DPZ Office Use only:
Case No. BA-25-009V
Date Filed 4/25/2025

Residential District Variance Petition

Residential Variance agency comment response
June 21, 2025

Mr. Zack Silvast raised some issues regarding my proposed pavilion/carport (file no. BA-25-009V) in a comment form dated May 1, 2025. I would like to offer some additional information in response:

Page 3 of 7 Drawn 6/21/25

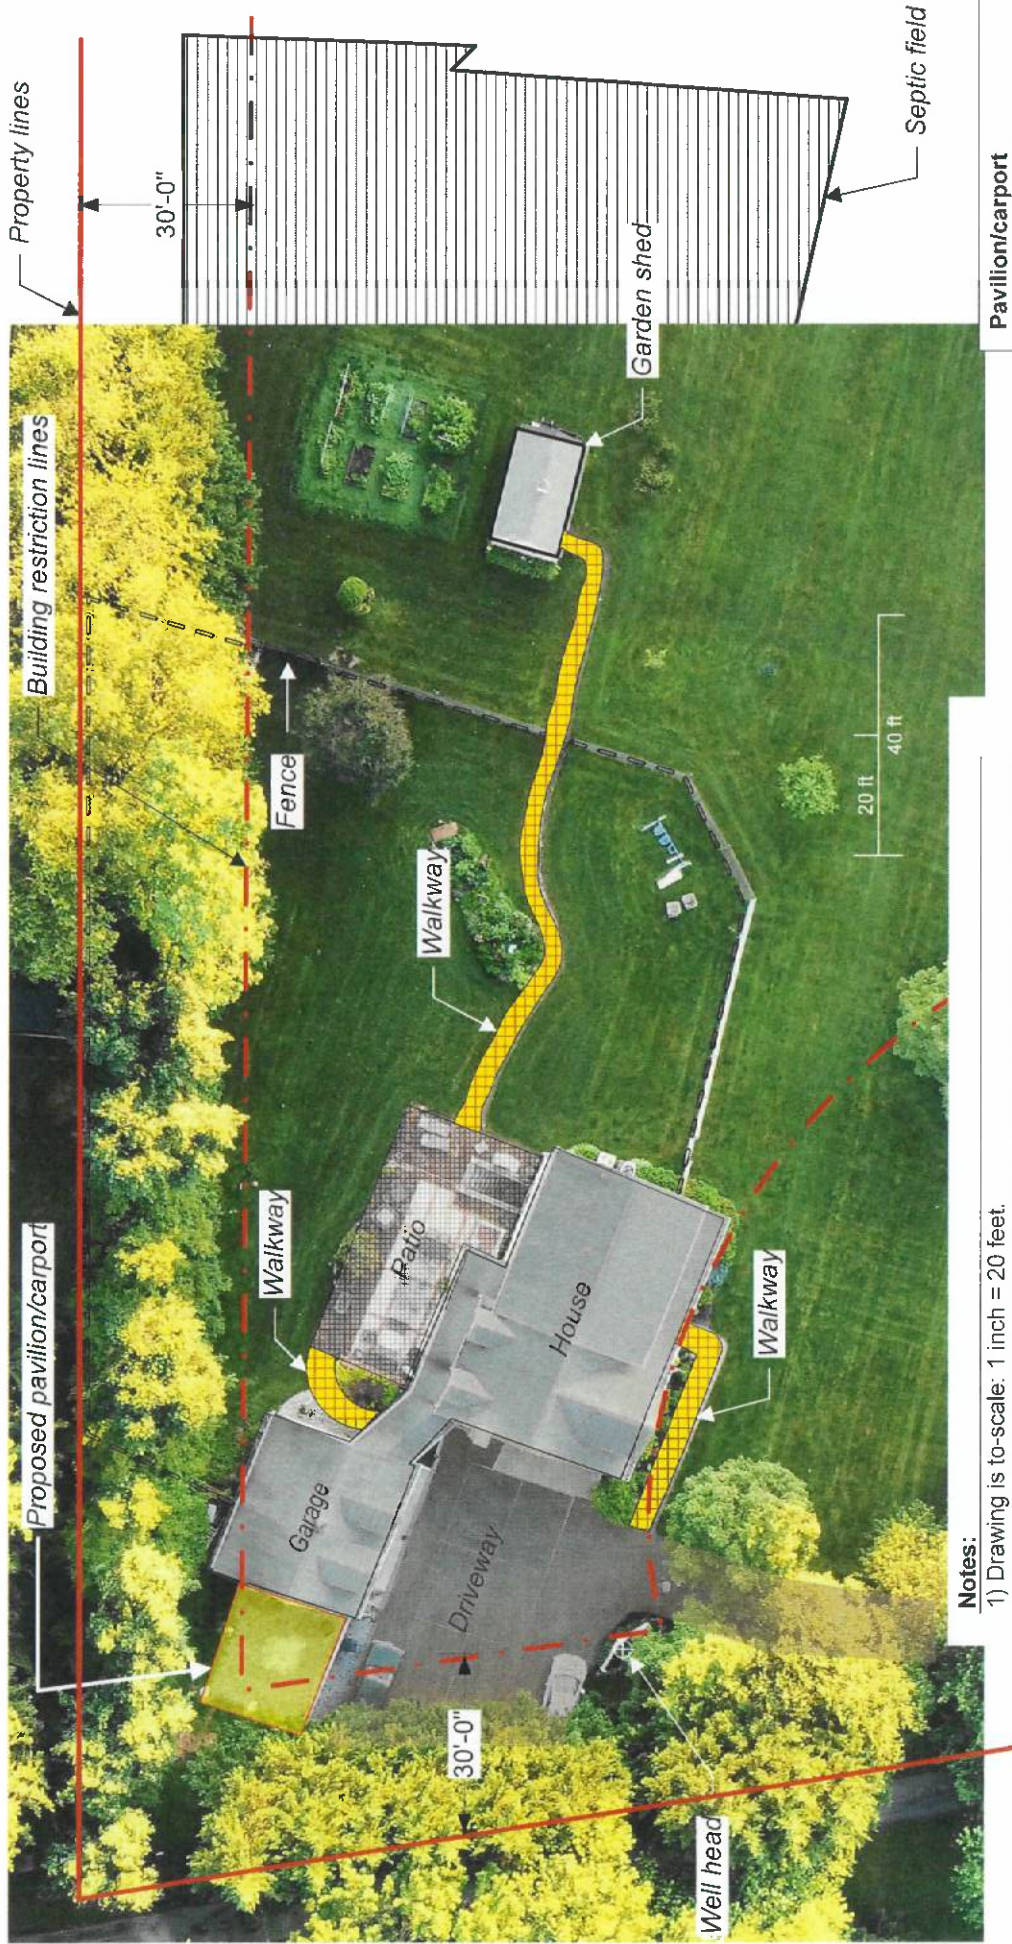
Regarding items flagged under “Residential Variance Plan,” here is my response to each item:

- I am re-submitting my drawings (included here as Attachment no. 2) now all drawn to a standard engineering scale.
- All detached accessory structures are now delineated in the revised drawings, in particular see drawings 2, 3, and 4 (of 7).
- A list of the lot coverage in square feet of all existing and proposed accessory structures is provided in Table 2.

- The length in feet of the breezeway connecting the rear porch to the existing two-car garage is described in drawing 6 of 7 in the revised drawing set. Shown in this drawing are two lengths as the breezeway is at an angle with respect to the house and the garage: the straight-line distance between the house (rear porch) and garage which is approximately 11 foot 9 inches, and the length measured along the axis of the breezeway which is approximately 13 foot 6 inches. Note that no matter how it's measured, the length of the breezeway does not exceed 15 feet, and also that the cumulative lot coverage of our detached accessory structures is 1,260 square feet, well within the 2,200 square foot limit mentioned in the June 5 letter.
- All existing well and septic components are delineated on drawings 2, 3, and 4 (of 7) in the revised drawing set (Attachment 2).
